# Access Compliance Report

## Public Rights-of-Way

### (Curb Ramps)

Intersection ID: 53537	Main Street: MACFARLANE_BV	Cross Street: IKEA_BV	Location:	N
ADA ID: 99EB0E8A2699	Ramp Type: Perp	Initial Pass/Fail: Fail	Overall Compliance: No	Severity Score: 10
Codes/Mitigation Info/Possible Solution		Field Measurements/Component Compliance

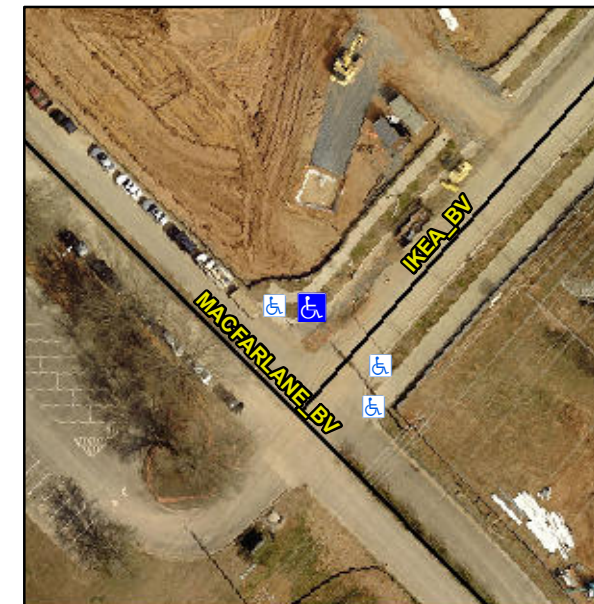
**Not Found, R304.5.1, R304.5.3**

Compliance	Description	Data	Compliance	Description	Data
N/A	Ramp Length (in)	95.0	Yes	Ramp Slope (%)	7.1
No	Ramp Width (in)	46.0	No	Ramp XSlope (%)	3.7
N/A	Flare Type LT	N/A	N/A	Flare Type RT	N/A
N/A	Flare Slope LT (%)	N/A	N/A	Flare Slope RT (%)	N/A
N/A	Flare Traversable LT?	N/A	N/A	Flare Traversable RT?	N/A
N/A	Landing Length (in)	N/A	N/A	DWS Provided?	N/A
N/A	Landing Width (in)	N/A	N/A	DWS Contrast?	N/A
N/A	Landing Slope (%)	N/A	N/A	DWS Length (in)	N/A
N/A	Landing X Slope (%)	N/A	N/A	DWS Full Width?	N/A
N/A	Landing Curb? (Y/N)	N/A	N/A	DWS Offset (in)	N/A
N/A	Shared Landing?	N/A			
N/A	Gutter Ponding?	N/A	N/A	Gutter Slope (%)	N/A
N/A	Gutter Lip Ht (in)	2.0	N/A	Gutter X Slope (%)	N/A
N/A	Painted X Walk1?	No	N/A	Painted X Walk2?	N/A
	X Walk 1 Direction	To SE		X Walk 2 Direction	N/A
N/A	X Walk 1 Width (in)	N/A	N/A	X Walk 2 Width (in)	N/A
	X Walk 1 Slope (%)	2.2		X Walk 2 Slope (%)	N/A
	X Walk 1 X Slope (%)	1.6		X Walk 2 X Slope (%)	N/A

**Remove & Replace Entire Ramp.**
